ADDENDUM NO. 2

Smoky Row Elementary School Additions and Renovations

Project No. 222033.00

January 14, 2026

E5.01

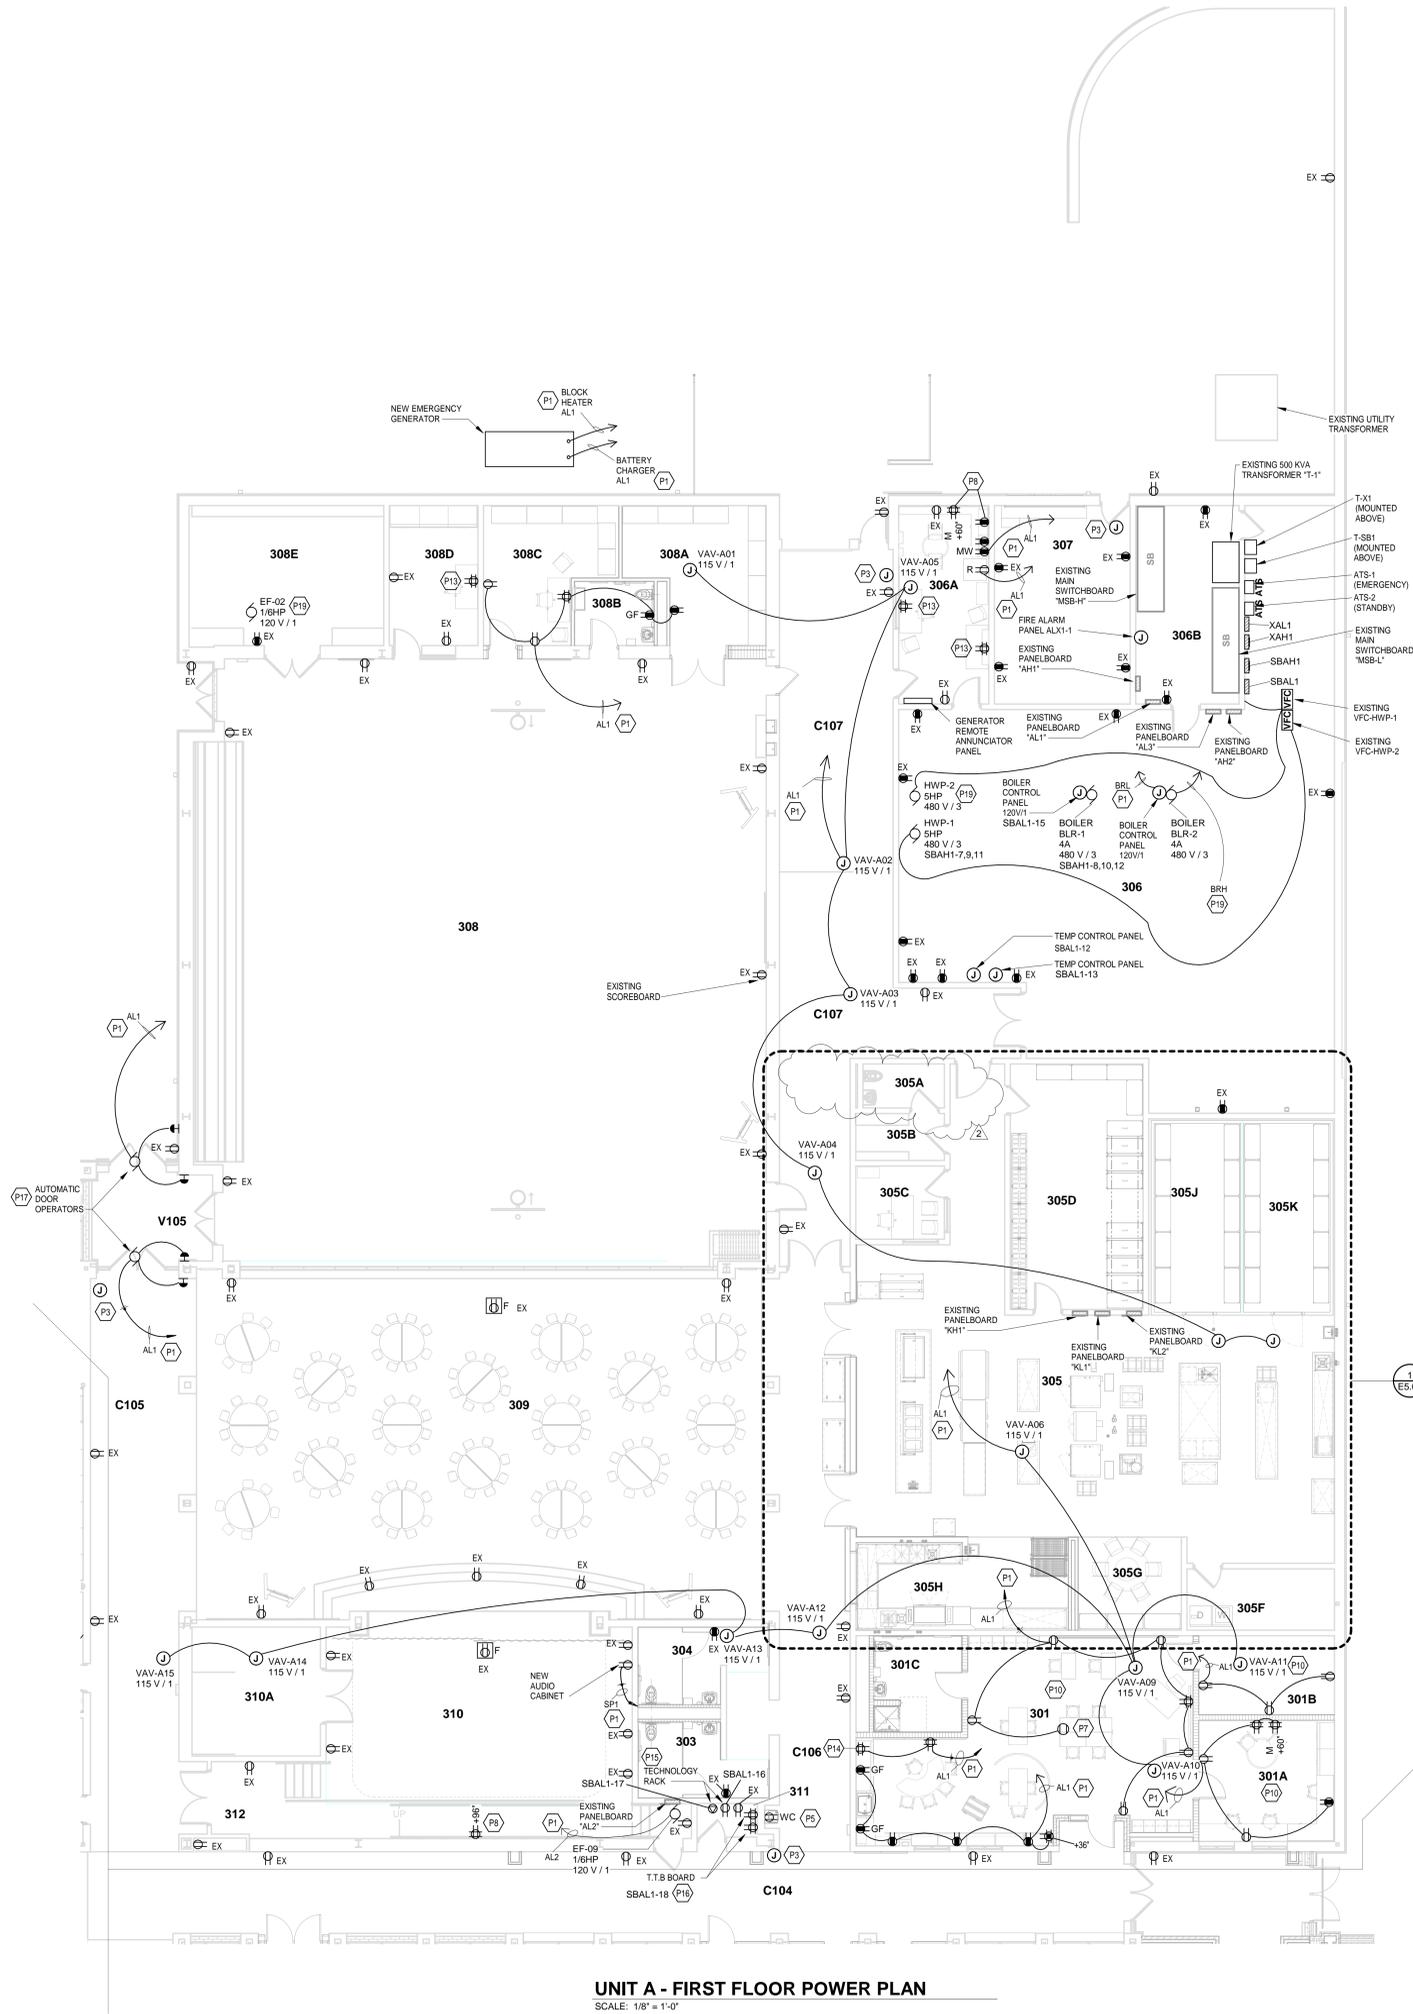
Question: E5.01: is there an existing emergency boiler shutdown system in the mechanical room or is one to be provided?

Response: It is going to be shown on the mechanical plans in addendum #2.

E5.03

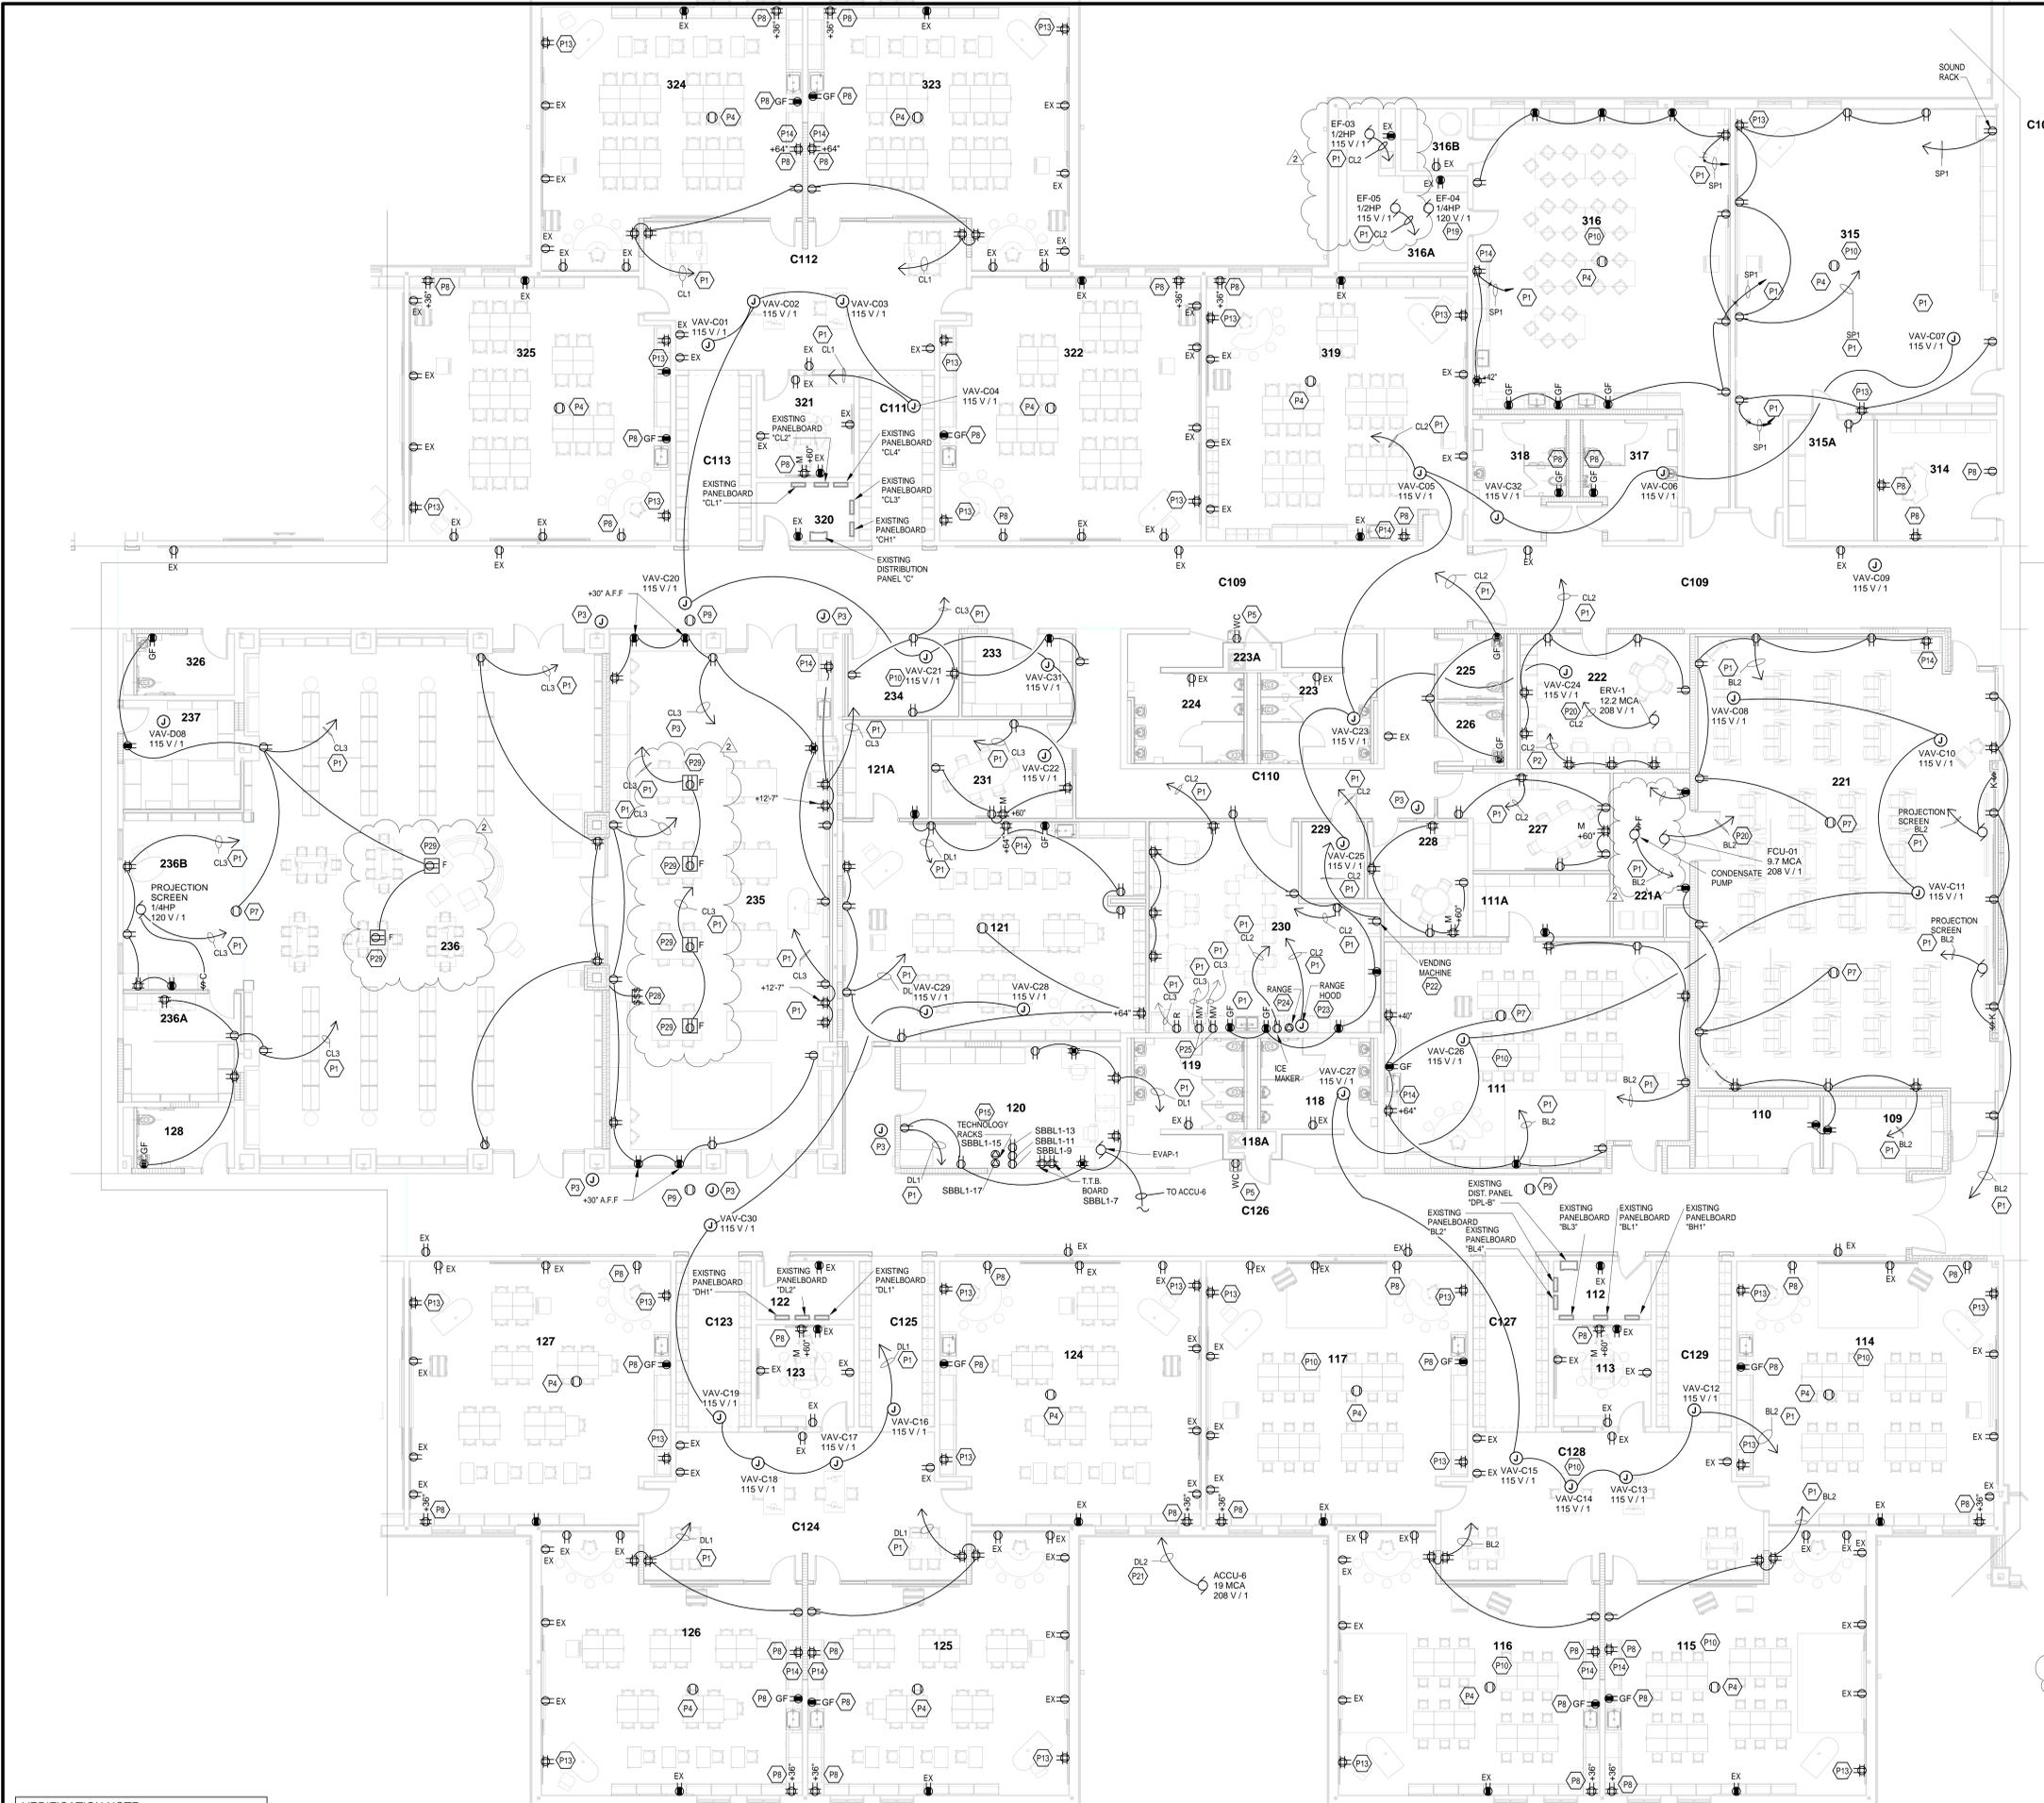
Question: E5.03: Rm 235 & 236 Please confirm if the FB's shown are new as there exist in this space and the denoliton plan.

Question: E5.03: RMs 221a & 222: Please verify the KN P2 placement. On ERV-1 or Condensate pump?

Response: They are new. Keynote will be added in addendum #2.

Response: It is P1, not P2. To be placed at condensate pump. Will locate in addendum #2.
